REPORT OF THE TECHNICAL COMMITTEE ON OBJECTIONS TO LICENCE CONDITIONS

TO:	Directors
FROM:	Technical Committee - LICENSING UNIT
DATE:	5 th March 2009
RE:	Objection to Proposed Decision (PD) for Nurendale Ltd (T/A Panda Waste Services Ltd), Waste Reg: W0140-03 located at Rathdrinagh, Navan, Co. Meath.

Appendix 1

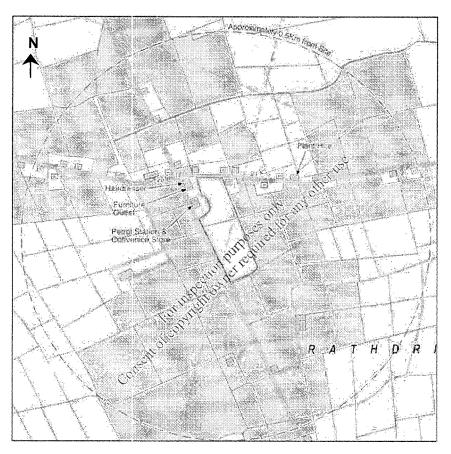
The closest noise sensitive receptors and residents are all located to the north, northeast or northwest end of the site (Appendix 1). The proposed expansion to the site boundary is to the south of the site. The expansion proposes to move the waste processing to the southern end of the site, in a new, entirely enclosed building. This proposal is also subject to grant of planning permission. One of the outcomes of relocating the waste processing to the other end of the site would be a reduction in noise, dust and odour nuisance to local residents from the site.

Recommendation: No change
